Presbyterian Road T&J Panel Repair Site Plan

SOIL/SITE EVALUATION
for ON-SITE WASTEWATER SYSTEM

OWNER: Worm Shinn / Alexander Applicant: Paul Volk (Buyer) APPLICATION DATE 1/15/14
ADDRESS: 672 Presbyterian Road Mooresville NC 28115 DATE EVALUATED: 12/28/13
PROPOSED FACILITY: 3BR PROPOSED DESIGN FLOW (.1949): 360 gpd PROPERTY SIZE: ±.677ac
LOCATION OF SITE: S. on Shearer Rd, N of Presbyterian Rd. Prop. on Lt. PROPERTY RECORDED:
WATER SUPPLY: ☑ Private ☐ Public ☒ Well ☐ Spring ☐ Other
EVALUATION METHOD: ☑ Auger Boring ☐ Pit ☐ Cut TYPE OF WASTEWATER: ☒ Sewage ☐ Industrial Process ☐ Mixed

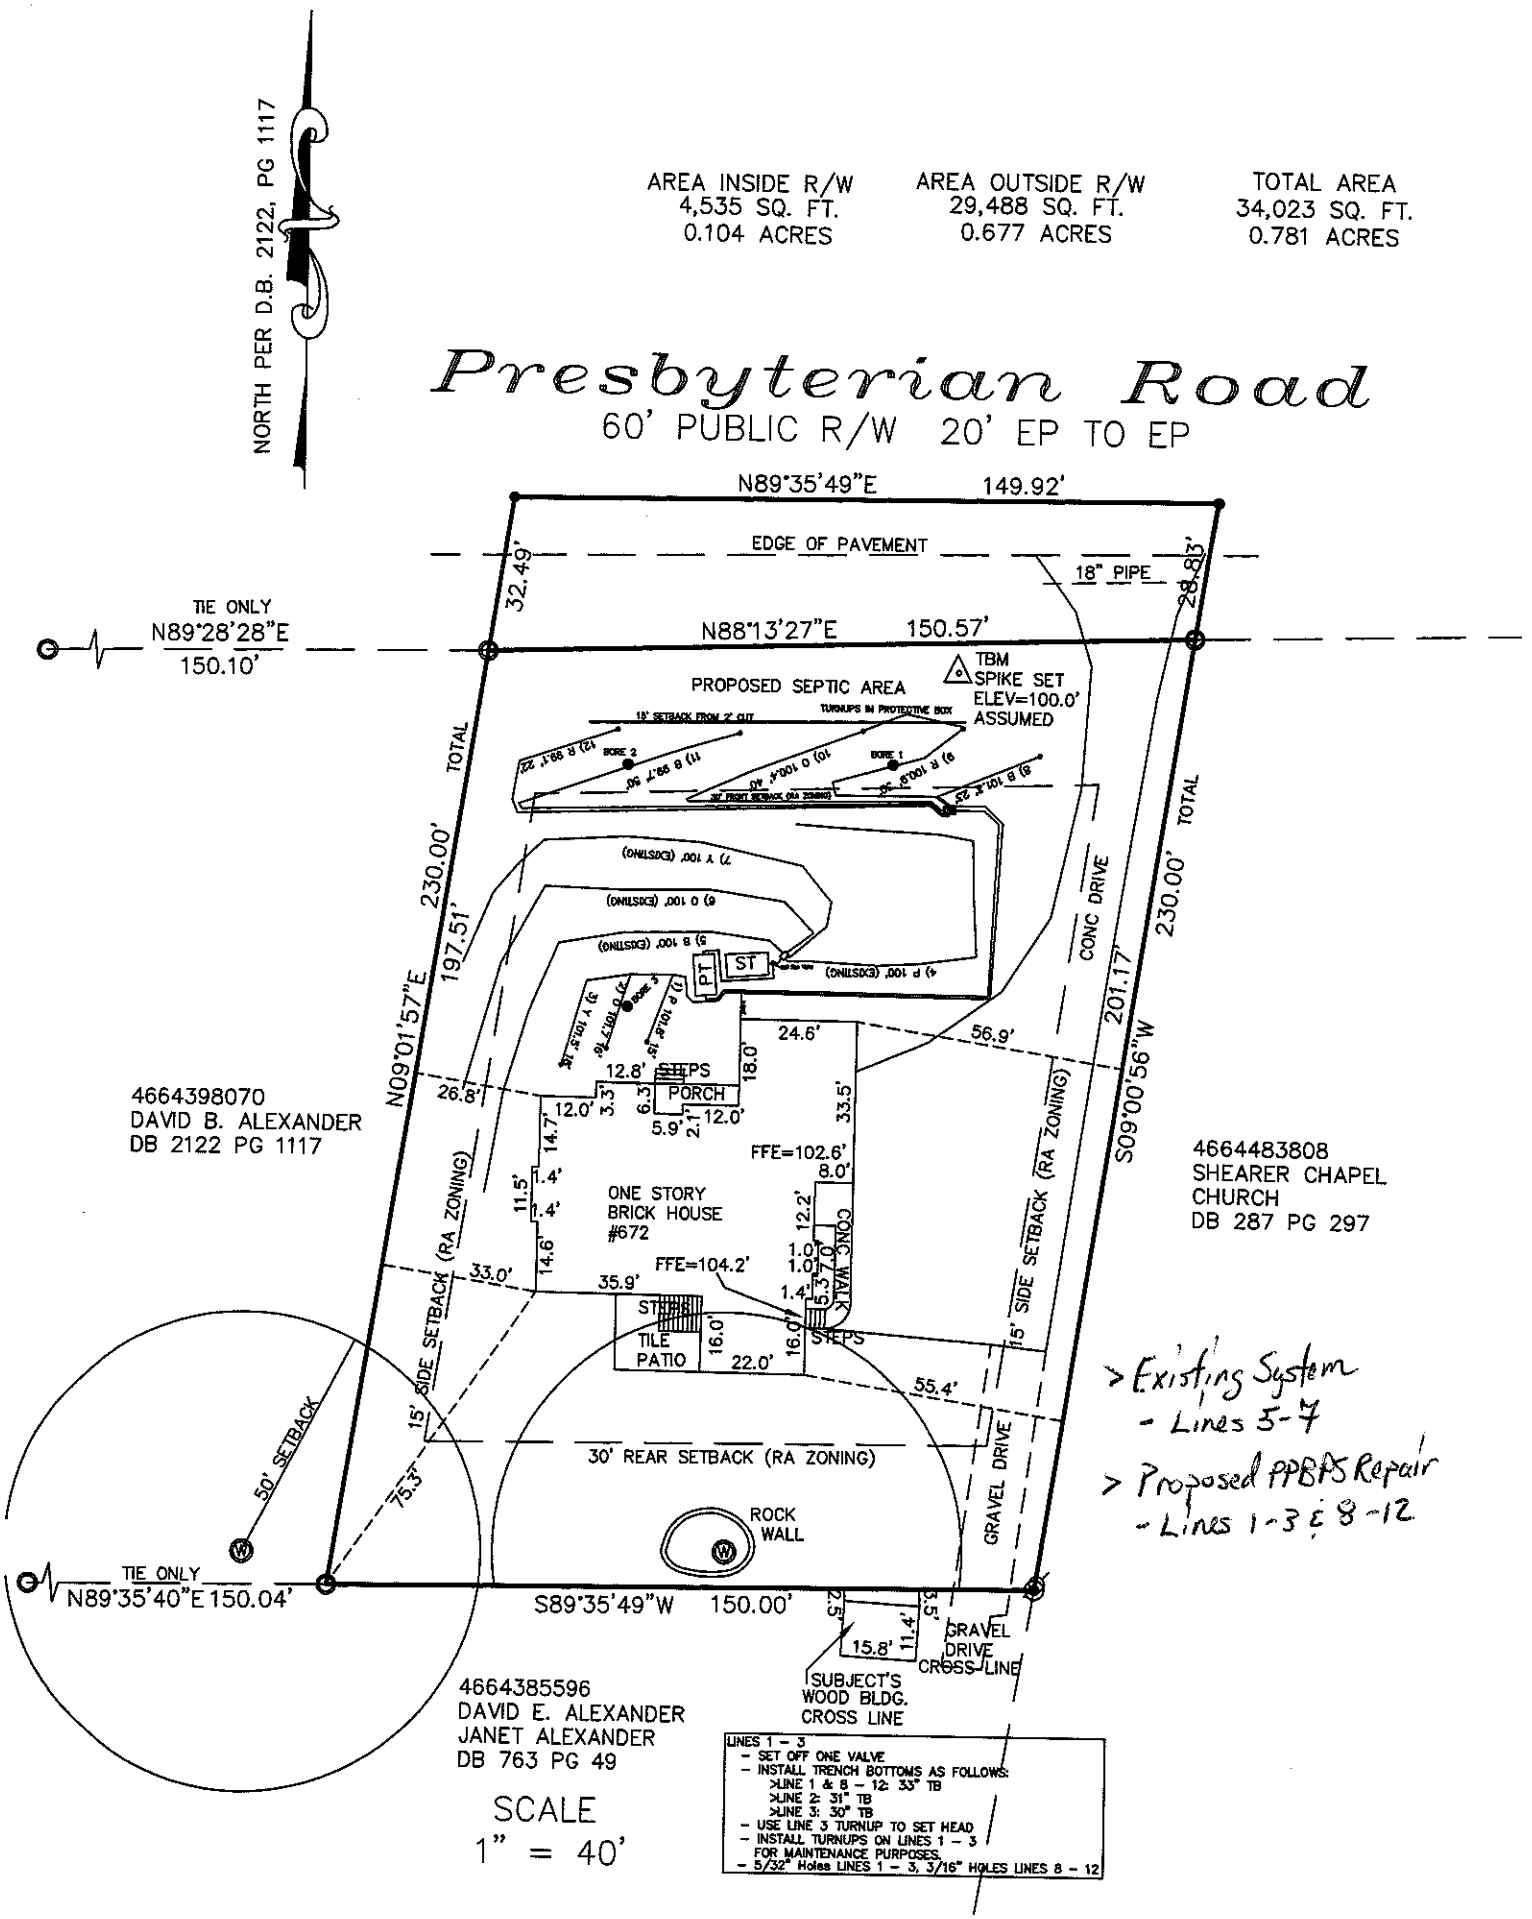
The drawing looks good to me you may want to add a note that the 5/32 inch or 3/16 inch hole size in LP P panel works best.
Given the nature of the length of pressure line going to the three short lines and that the lines are close to the home I possibly would does them at a reduced rate.
This could be achieved by putting these three short lines that are hooked together at a 2 foot head of elevation with a 5/32 inch hole.
All the other lines would then be put at a 2 foot head of elevation with a 3/16 inch hole. This would better balance the distribution and keep possible problems away from the home
Tim Johnson
